<b>Office Action Summary</b>	Application No.	Applicant(s)
	09/802,449	JOHNSON, PETER W.8
	Examiner	Art Unit
	Ming-Hun Liu	2697

## DETAILED ACTION

Claims 1-2, 5, 9, 15, and 19 are rejected under 35 U.S.C. 102(e) as being anticipated by U.S. patent number 5,268,674 to Howard et al.

**FIGURE 13**

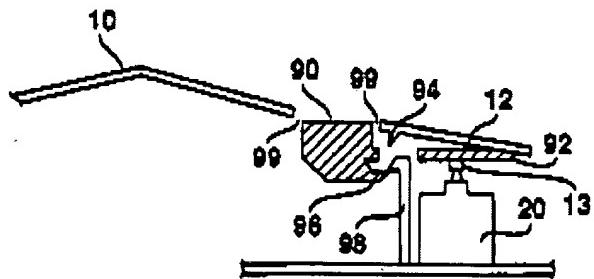
Referring to claim 1, Howard describes a button assembly that is very similar to the claimed invention. Howard discloses in figure 13 a button assembly comprising a first cantilever beam (92) having a first end and second end, the first end being movably coupled to an electronic input device through a first fulcrum (13) at the first end; a second cantilevered beam (12) having an exposed button portion, the second cantilevered beam being movably coupled to the first cantilevered beam through a second fulcrum (at arrow 92).

In reference to claim 2, as seen from the figure 13, the second fulcrum comprises a flexible hinge disposed between the second cantilevered beam and the second end of the first cantilevered beam.

In reference to claim 15, in figure 13 Howard discloses a computer pointing input device comprising a housing, a palm portion of the housing configured to receive a user's hand (10), a spring beam flexibly coupled to the housing through a first fulcrum (13), a switch button having a palm end and a finger end where the switch button is flexibly coupled to the spring beam through a second fulcrum (at arrow 92), the second fulcrum being nearer to the finger end of the switch button than the palm end of the switch button. A plunger (13) coupled to the switch button extending towards an electronic switch (20), the plunger configured to actuate the electronic switch upon application of a sufficient force to the switch button by the user.

**FIGURE 9b**

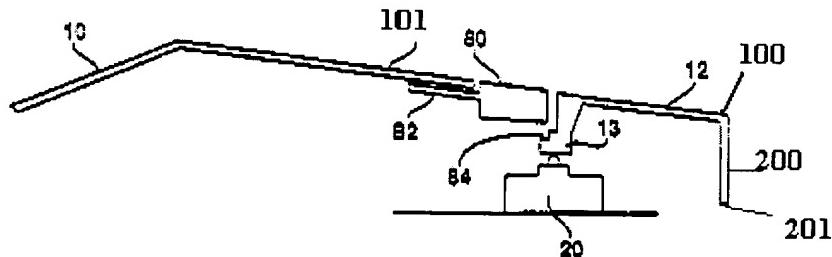
In reference to claim 5, Howard discloses in figure 9b a computer pointing input device comprising a housing (10), a palm portion of the housing configured to receive a user's hand (10), a distal portion of the housing extending generally away from the palm portion (101) and a switch button having a palm end and a distal end (12). It can be seen clearly from figure 9b that the switch button is configured to actuate an electronic switch within the computer pointing input device upon application of sufficient force to the switch button by the user, the switch button being movably coupled to the housing so as to move about a fulcrum (100), the fulcrum being nearer to the distal end than to the palm end of the switch button.

In reference to claim 9, again referring to figure 9b of Howard, it can be seen that Howard discloses a spring beam (200) coupled to the switch button through the fulcrum at the first end (100) and being coupled to the housing at the second end through a second fulcrum (201).
